L73X-
R.01.18

To: Official after-sales network.
Subject: Replacement of homologation label.
Date: 25/05/2018
Pages: 7

Replacement of homologation label.

Centenario Coupé And Roadster

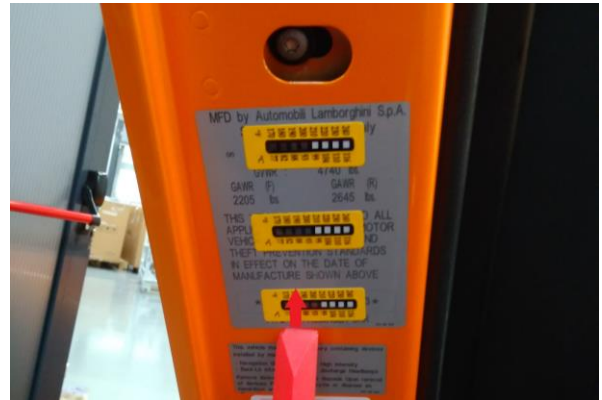
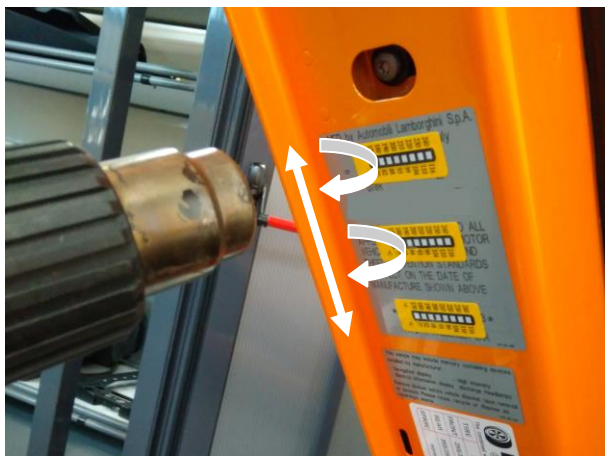
1. Identify the label to remove in the lower part of the driver door (see image).

2. Remove the upper seal.

3. Apply three heat reading stickers to monitor the temperature on the entire surface of the label.

- Heat the adhesive label using the heat gun. Stand about 10-15 cm away and perform even circular movements over the entire surface in order to uniformly heat the entire label do not focus on one particular point for more than 2 seconds; otherwise the paint may become damaged. Consequently, by making use of a removing plastic bodywork tool, gently remove the sticker by scratching and continuously applying heat.

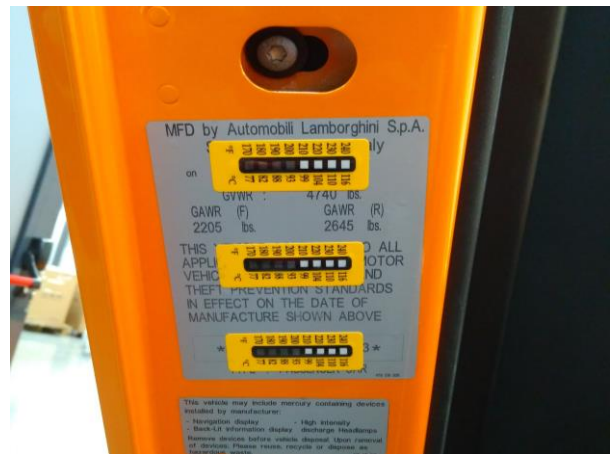
Do not cross the temperature of 93°C (210°F) as the paint could come off near and under the identification label.

In case of crossing the limit temperature of 93°C (210°F), stop the operation and let the label's surface cool down for a couple of minutes to guarantee its proper cooling.

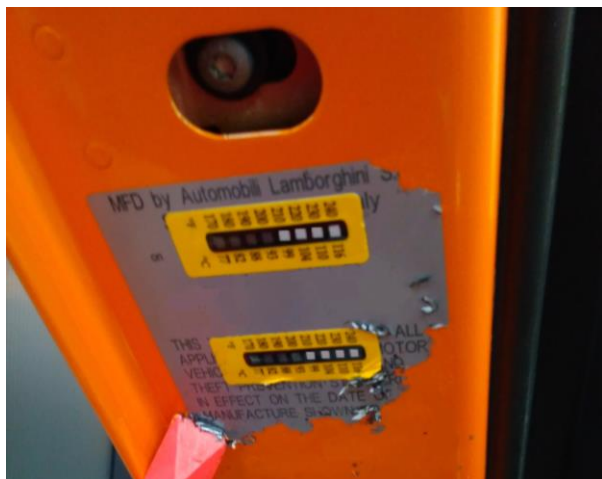
It is normal if the homologation label comes off in fragments, as shown in the picture below.

5. Completely remove the label and clean the surface with a soft cloth and a degreaser to eliminate all glue residue.
